RE: WP-18-135

ALTERNATIVE COMPLIANCE APPLICATION

ALTERNATIVE COMPLIANCE EXHIBIT
7461 MONTEVIDEO RD
 LOTS 3 & 4; PLAT BOOK 5, PAGE 25
 TAX MAP 43 GRID 16 PARCEL 96
 HOWARD COUNTY, MARYLAND

ENVIRONMENTAL RESTORATION PLAN
7461 MONTEVIDEO RD
TAX MAP 43 GRID 16 PARCEL 96
HOWARD COUNTY, MARYLAND

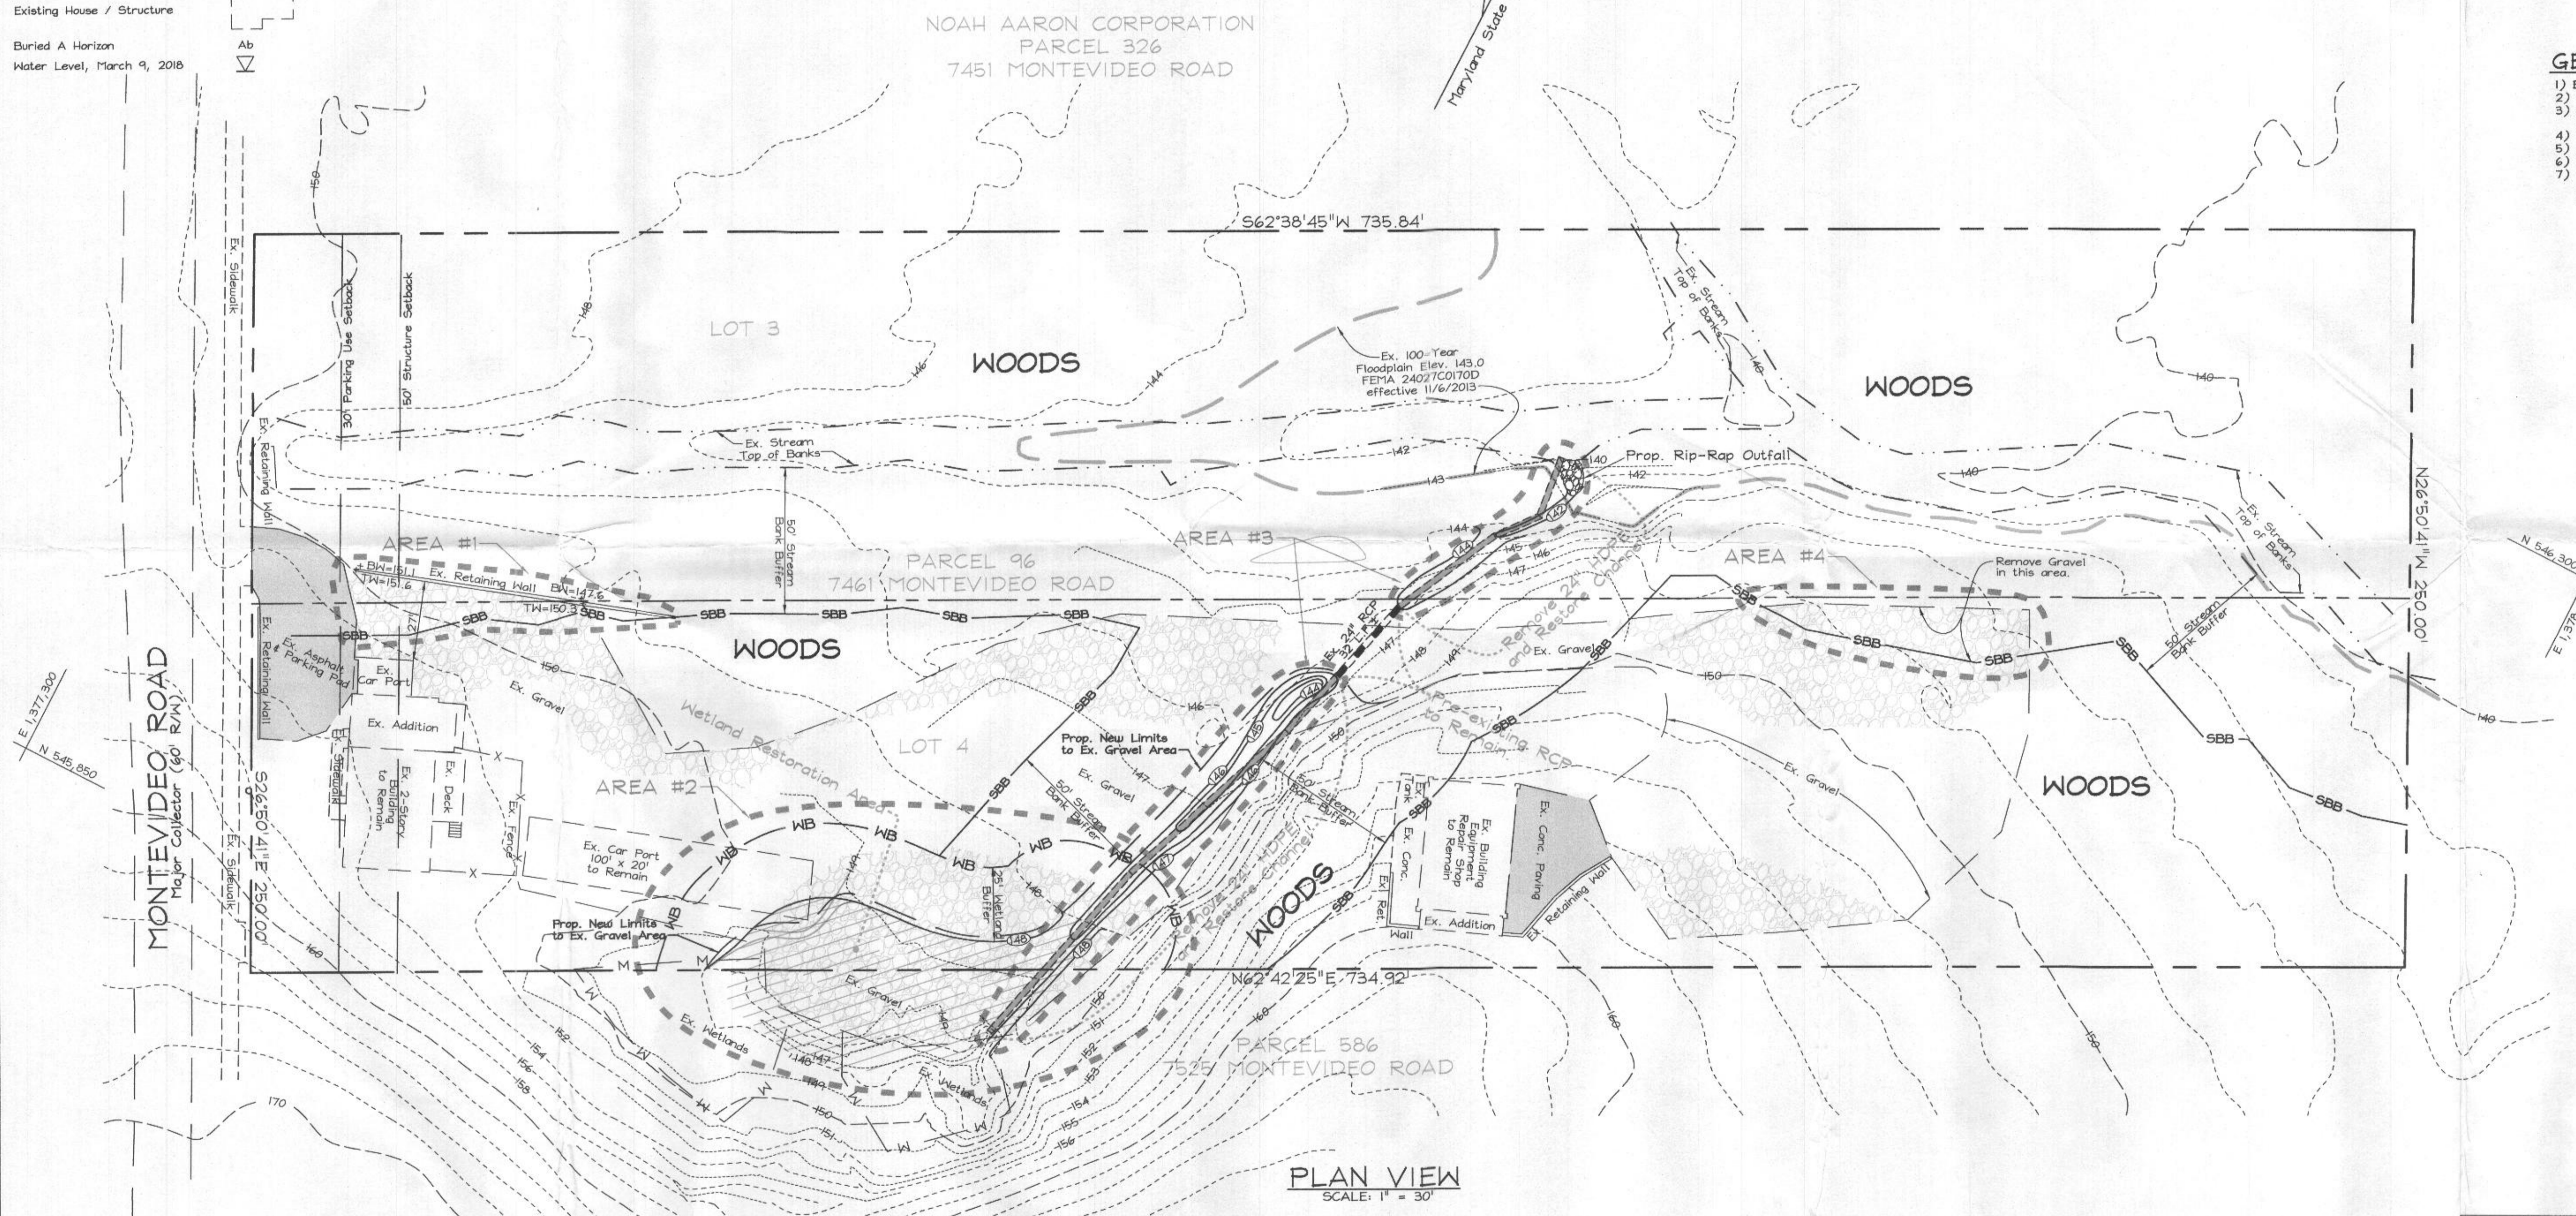
1. The Health Department has no objection with the assumption that the rear building is also connected to public water and public sewer.

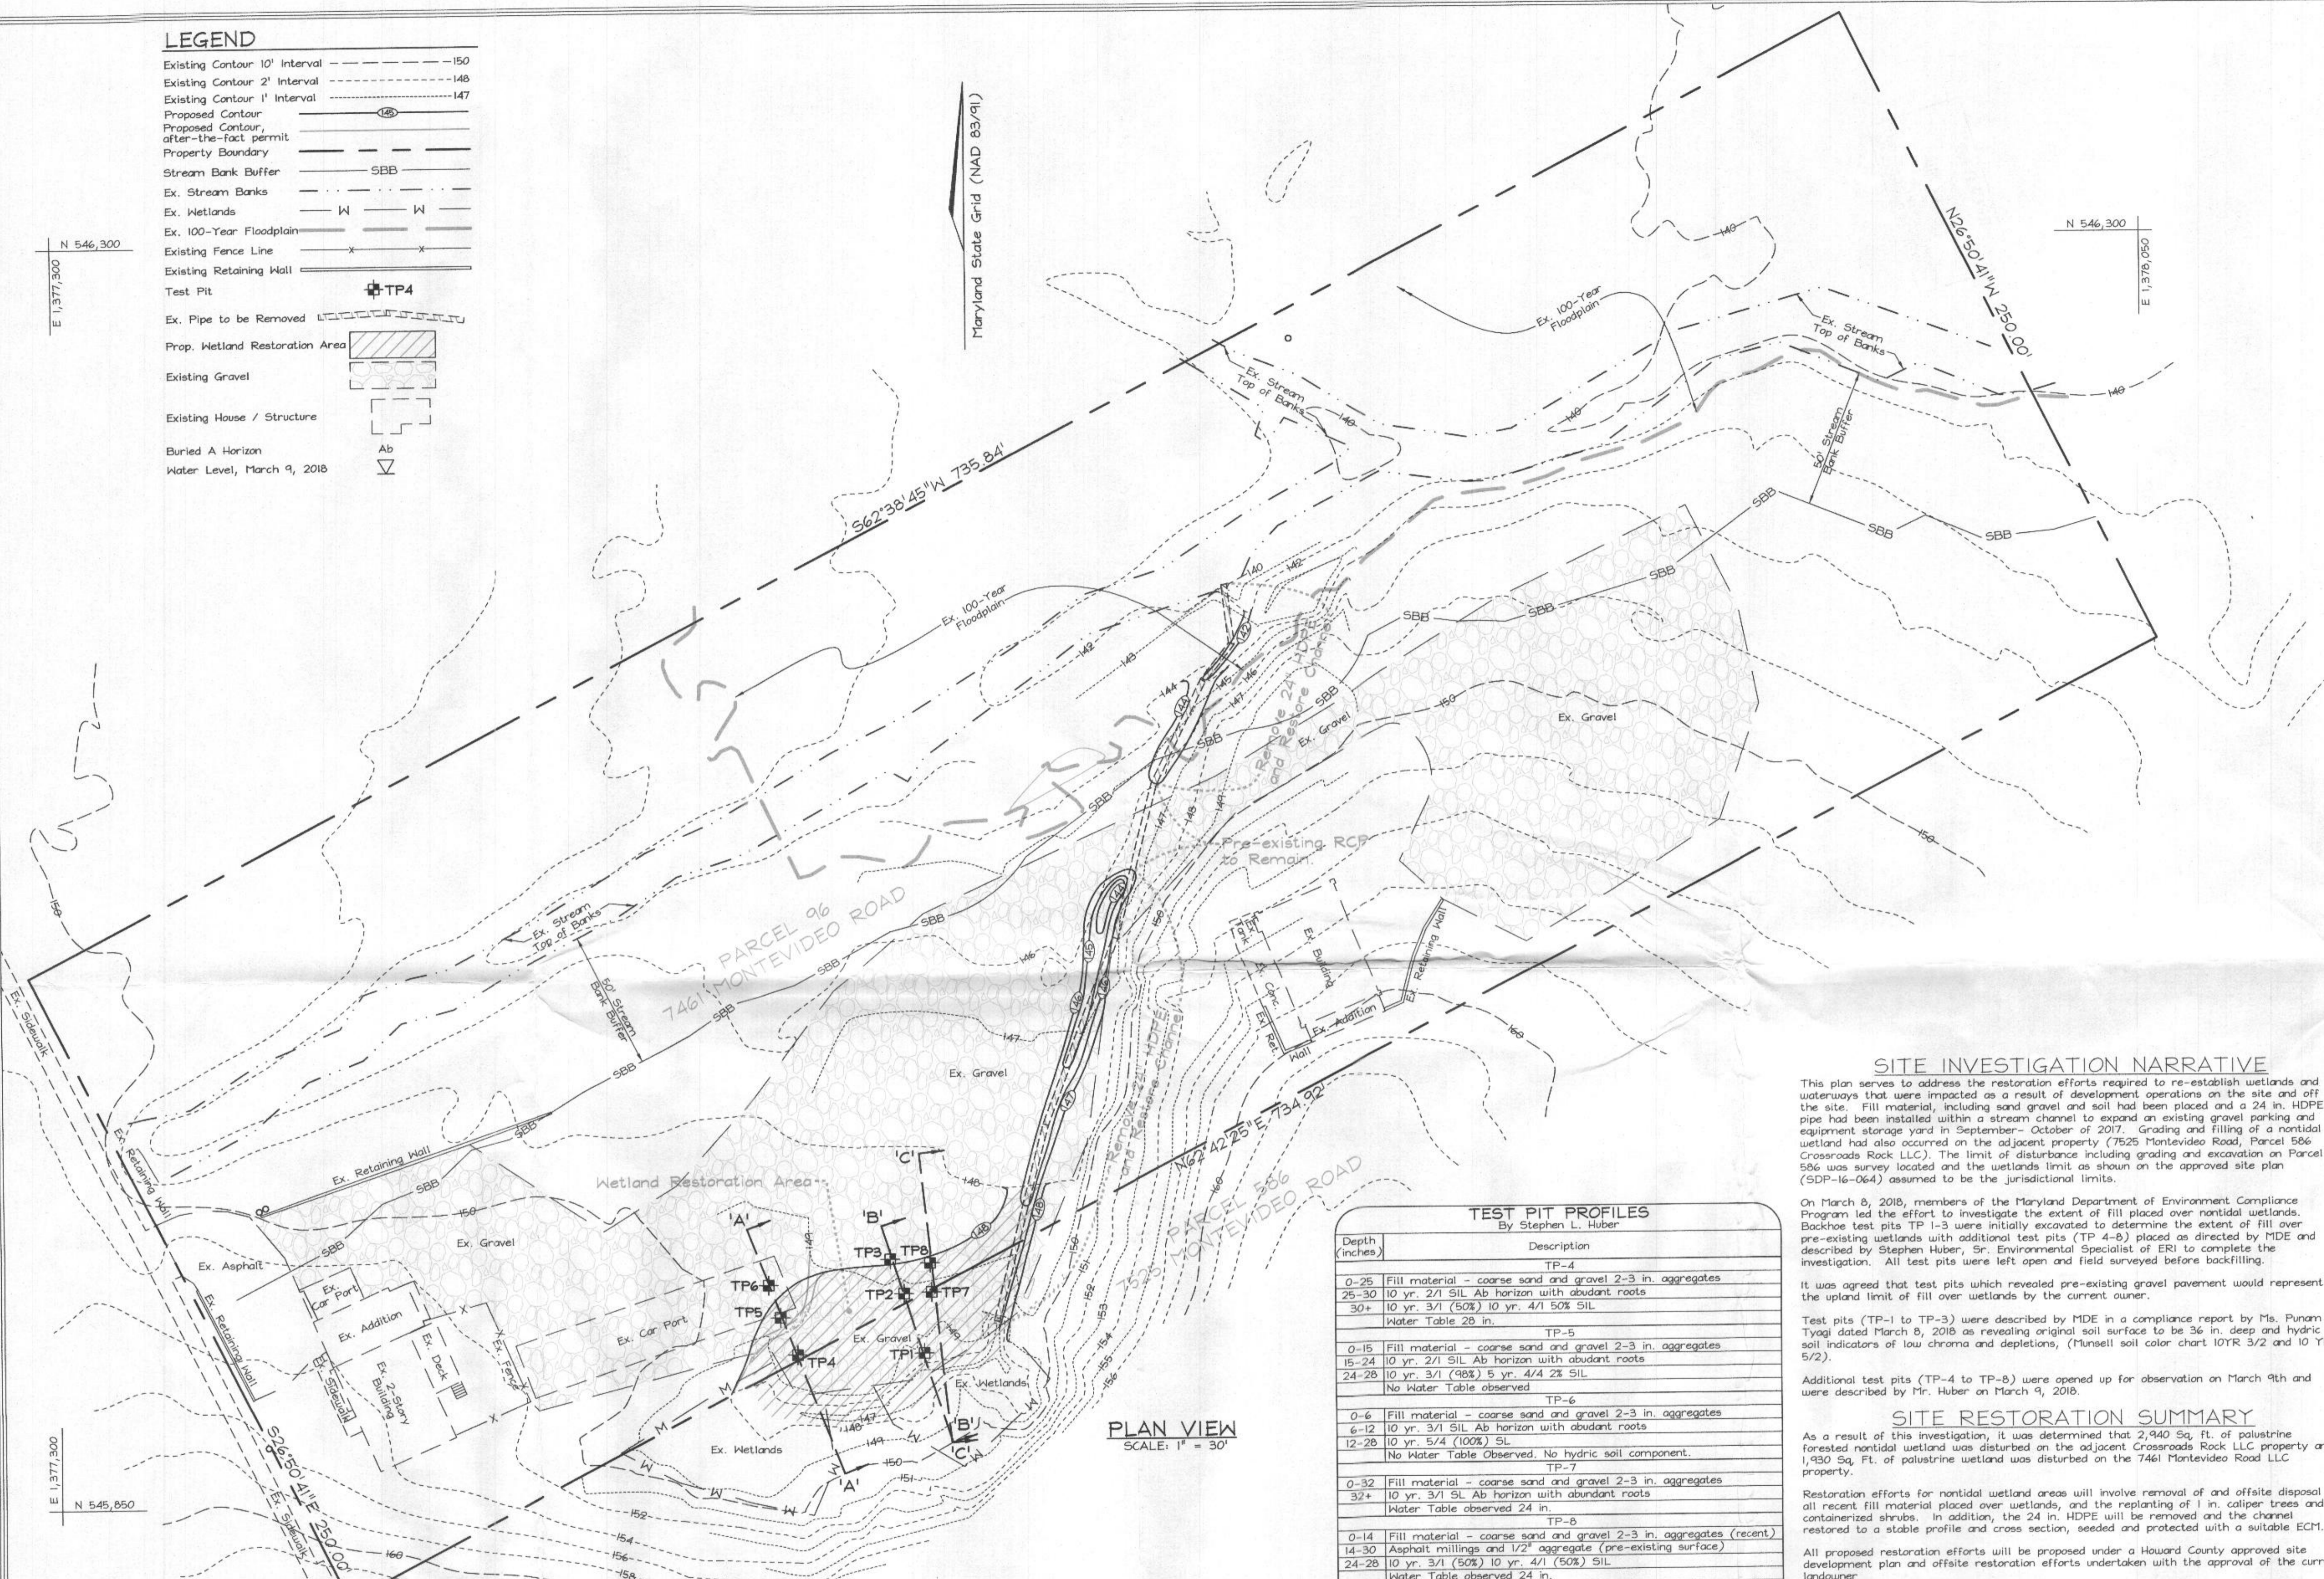
Good morning and thank you for an opportunity to review the plan. We've a few comments relative to nontidal wetlands.

1. The area indicated in red as the wetland restoration area is acceptable. The limits look correct to us.
2. We will need to see a planting plan listing the species and number of trees/shrubs. The plan must also include an appropriate shade tolerant wet mix of emergent vegetation both for stabilization and vegetative diversity.

3. The plan suggests that the landowner wishes to apply for an authorization to leave a portion of the wetland fill by seeking an after-the-fact authorization. Before considering that proposal, we would first want to hear from the County with regard to whether they will allow the open-sided shed to remain. If the County indicates that it can be approved, then an application would have to be submitted. Be advised that there are alternatives which would have avoided all wetland impact had an application been submitted prior to construction. Explaining why none of those alternatives (specifically size, location and/or orientation) are feasible will be a tall hurdle to clear.

Zach, in addition to Sean's comments compliance have few comments in regards to the restoration plan.

1. E& S controls and the details should be included in the restoration plan.
2. More details about the HDPE pipe that will be removed, i.e. length of the pipe and impacts of the disturbed area should be included in the drawings. Please explain how you plan to restore the impacted area.
3. During the process how you will manage the water in the stream, please explain if you plan to install water diversion/dewatering method. If yes, please provide details.
4. What equipment will be used to remove the fill and to remove the pipe from the 100 year floodplain and nontidal wetlands and waterway.
5. As mentioned by Sean we would like to have planting plan and site stabilization plan.
6. Sequence of construction for all the items should be included in the restoration plan.
